## **DEVELOPMENT APPLICATION ACCESS REVIEW**

## **PROPOSED JUNIOR SCHOOL PHASE 1**

St Philips Chistian College Gosford Campus  
Narara Creek Road  
NARARA NSW

Report prepared for:	St Philips Christian College c/- Ian Easton Architect 112 The Lane WICKHAM 2293
Report prepared by:	Lindsay Perry Philip Chun Access Pty Ltd Suite 404, 44 Hampden Road ARTARMON NSW 2064
Report No:	AN15-205523 20150904 DAR_LP.doc
Date:	04 September 2015

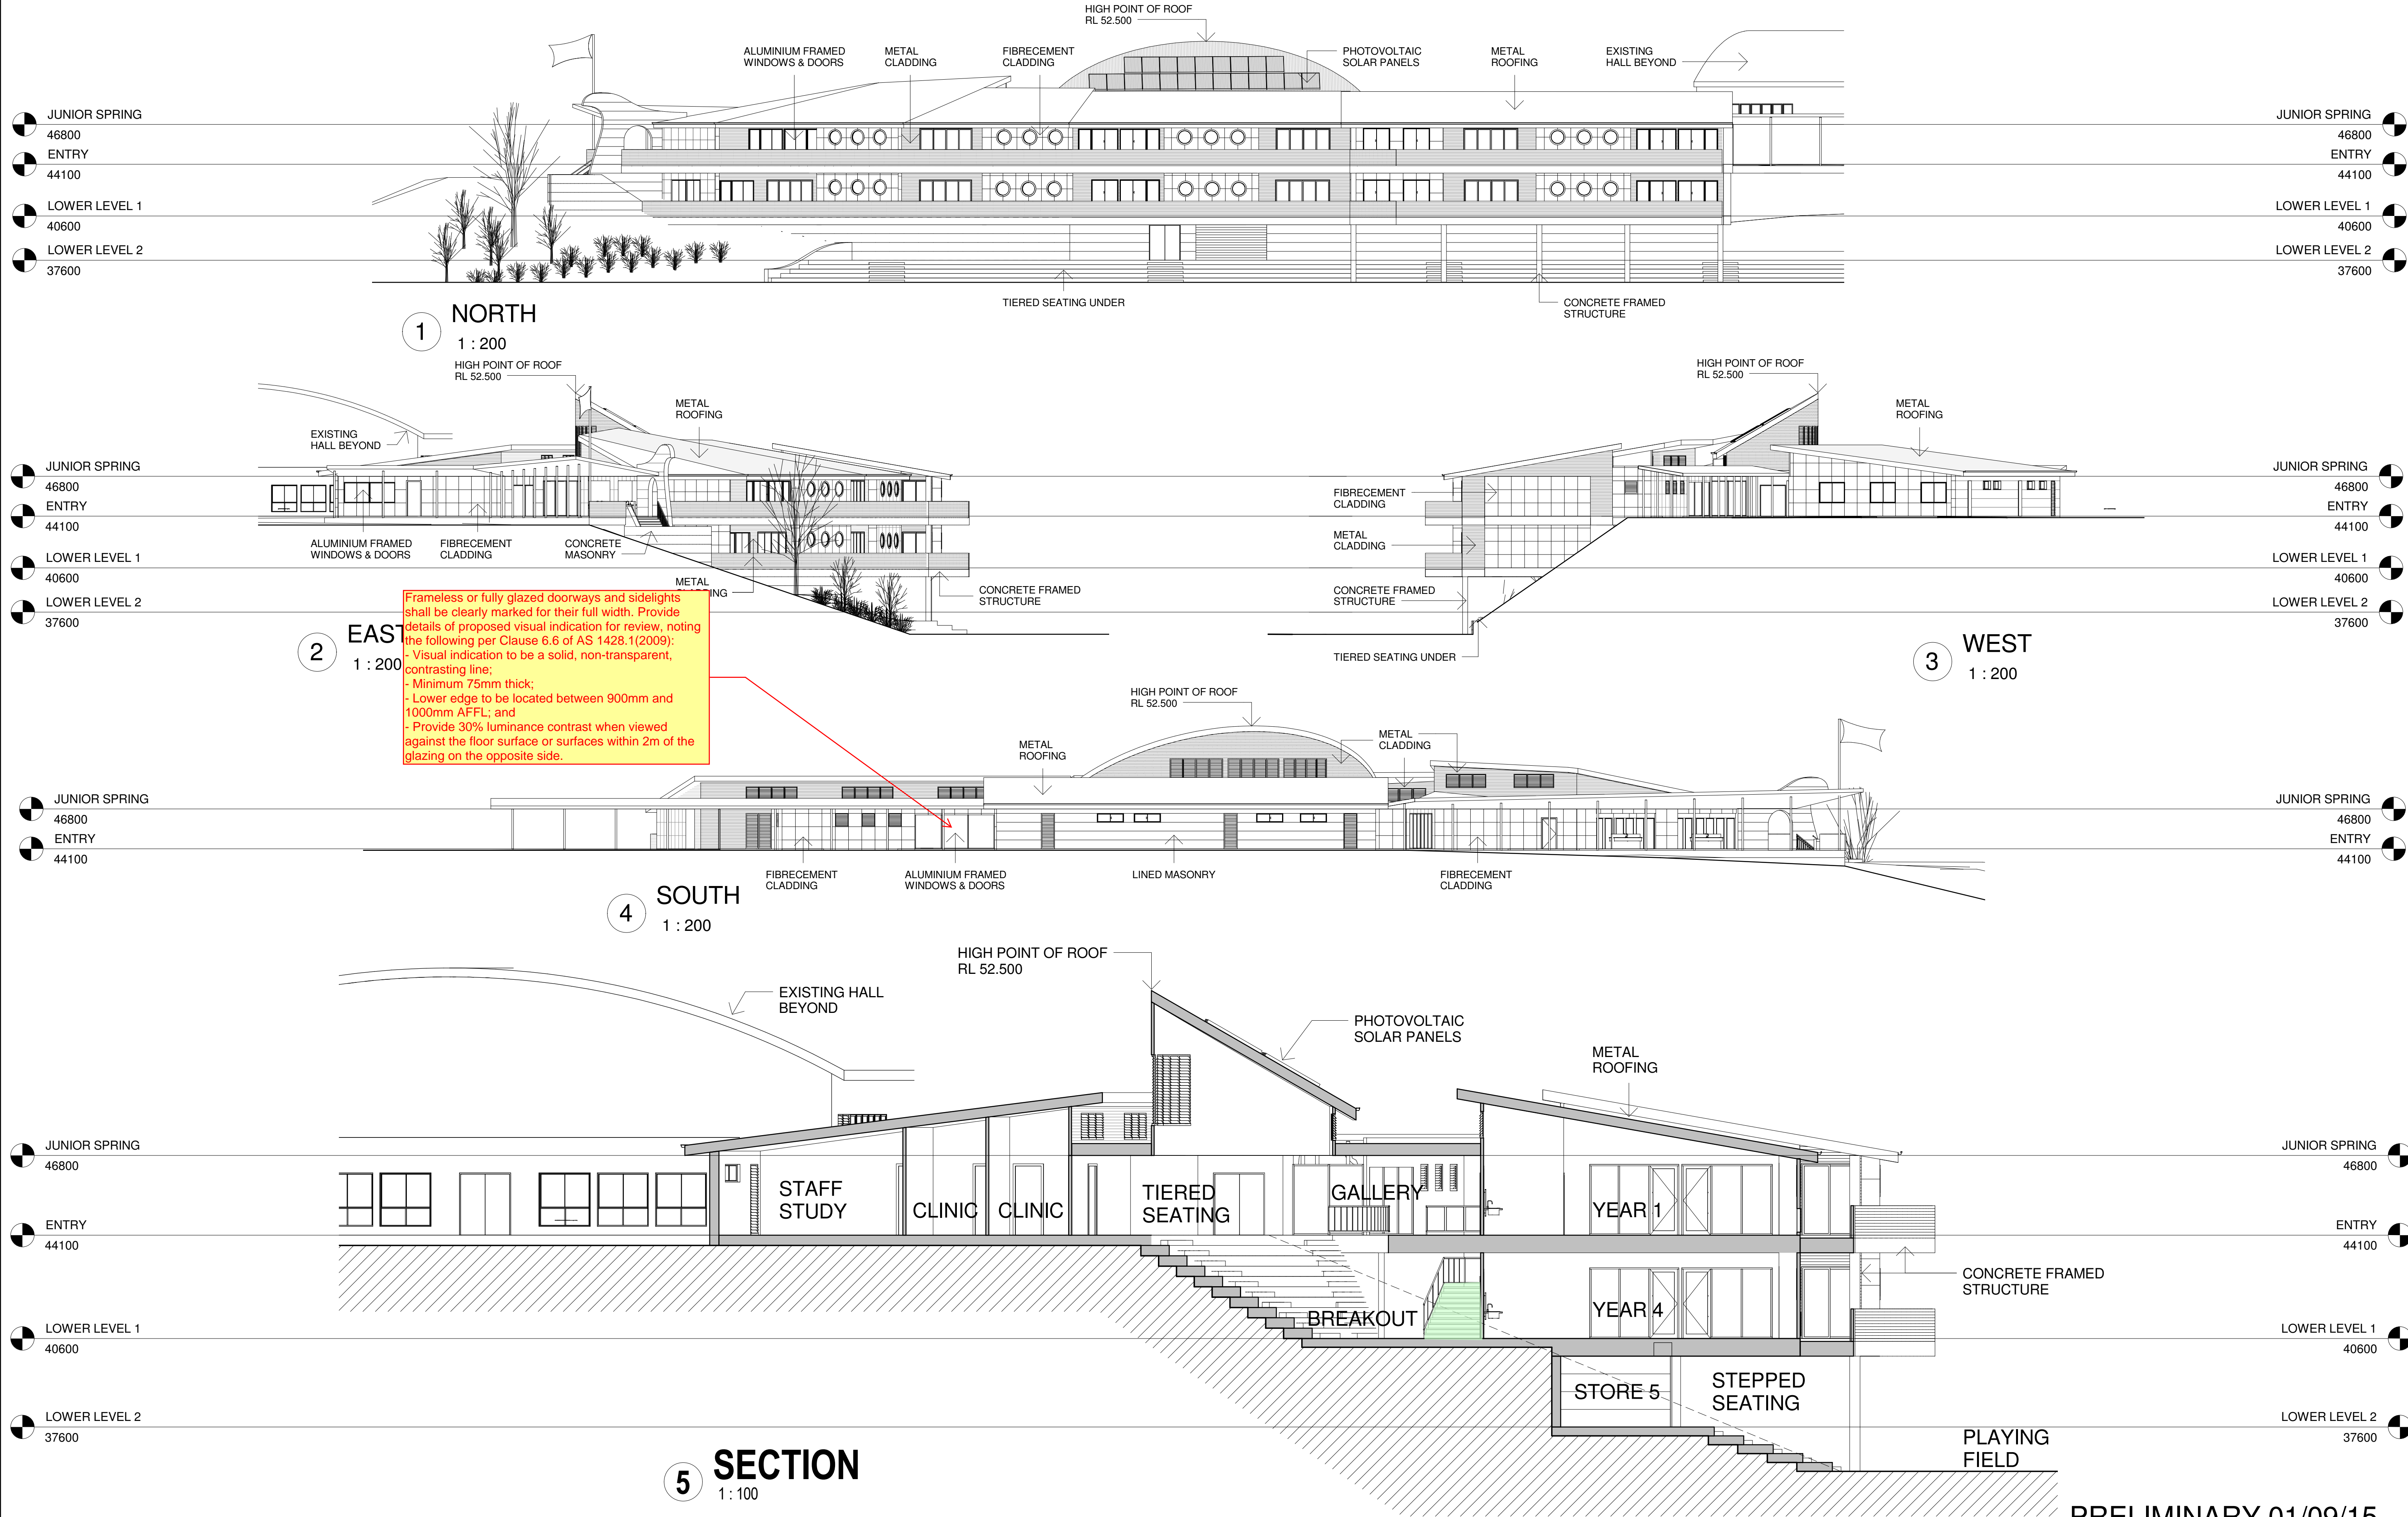
All pathways and walkways are to be constructed with no lip or step at joints between abutting surfaces (a construction tolerance of 3mm is allowable, 5mm for bevelled edges -refer to Figure 6 of AS1428.1(2009)).

Maximum allowable gradient of the walkway is 1:20 and maximum length between landings to be 15m (for 1:20 gradient). Landings to be a minimum 1200mm in length (where there is no change in direction). For changes in direction of 180°, landings to be 1540mm in length – refer to AS1428.1 (2009), Clause 10.8.

Door threshold are to be level to provide seamless entry as part of the accessible path of travel. Maximum allowable construction tolerance is 3mm for compliance with AS1428.1 (2009), 5mm where bevelled edges are provided between surfaces – refer to Figure 6.

For glass doors, provide decals to assist persons with a vision impairment. Decals to be solid and have a minimum 30% luminance contrast to the background colour and be not less than 75mm high located within the height range of 900-1100mm above the finished floor level. Decals are to be solid pattern to AS1428.1 (2009) Clause 6.6.

All doorways within the accessible path of travel to have complying circulation areas as illustrated in AS1428.1 (2009), Figure 31. Circulation areas are to have a maximum crossfall of 1:40.

Provide decals to assist persons with a vision impairment. Decals to be solid and have a minimum 30% luminance contrast to the background colour and be not less than 75mm high located within the height range of 900-1100mm above the finished floor level. Decals are to be solid pattern to AS1428.1 Clause 6.6.

Where the stair intersects with an internal corridor, the stair shall be set back in accordance with AS1429.1 (2009) Figure 26C/D to allow adequate space for handrail extensions and tactile indicators.

Provide handrails, with extensions, to both sides of the stair (AS1428.1 (2009), Clause 11.2). Handrails are to have an external diameter between 30-50mm to assist persons with a manual disability such as arthritis. Handrails should be continuous around the landings where possible. Handrails are required on both sides of the stair to cater for left and right handed disabilities. A central handrail is also an acceptable solution where adequate width is available.

Provide tactile indicators at the top and bottom of the stair to comply with BCA Part D3.8 and AS1428.4.1 (2009).

A minimum clear dimension of 1400mm is required from the toilet pan to any other fixture (see figure 43). For the basin, a minimum dimension of 425mm is required from the centreline of the basin to the side wall and height of basin to be between 800 and 830mm.

Provide a backrest to accessible toilets to comply with AS1428.1, Clause 15.2.4.

Doorways are to have a minimum clear opening width of 850mm to comply AS1428.1 (2009), Clause 13.2 as part of the accessible path of travel. Adequate circulation area at the latch side of the doorway is required to allow independent access to the facility – for details refer to AS1428.1, Figure 31.

Circulation space in front of the shower is to be provided as illustrated in AS1428.1, Figure 47.

Provide grabrails to PAD cubicles to comply with AS1428.1, Clause 17 and Figure 53A.

Doors are to have a minimum opening width of 700mm and comply with AS1428.1 Figure 53B.

Provide signage to the PAD cubicles to comply with AS1428.1, Clause 16.4.

Provide 900x900 circulation space in front of pan and each side of doors on path to the toilet. Door are not to swing into circulation spaces.
